Access Compliance Report

Public Rights-of-Way

(Curb Ramps)

Intersection ID: 18391	Main Street: LYNBROOK_DR	Cross Street: RAMA_RD	Location: NW
ADA ID: 9D140A1BF27C	Ramp Type: PerpDiag	Initial Pass/Fail: Fail	Overall Compliance: No
		Severity Score: 25

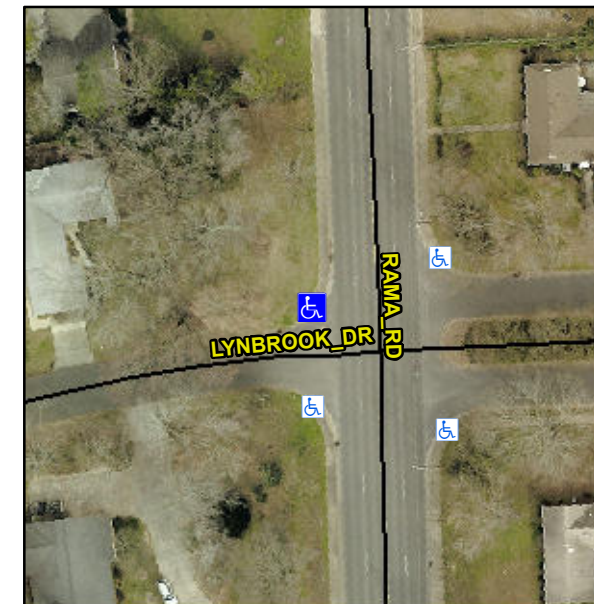
Not Found, R304.2.2, R304.5.3

Remove & Replace Curb Ramp With Two New Directional Ramps or Equivalent.
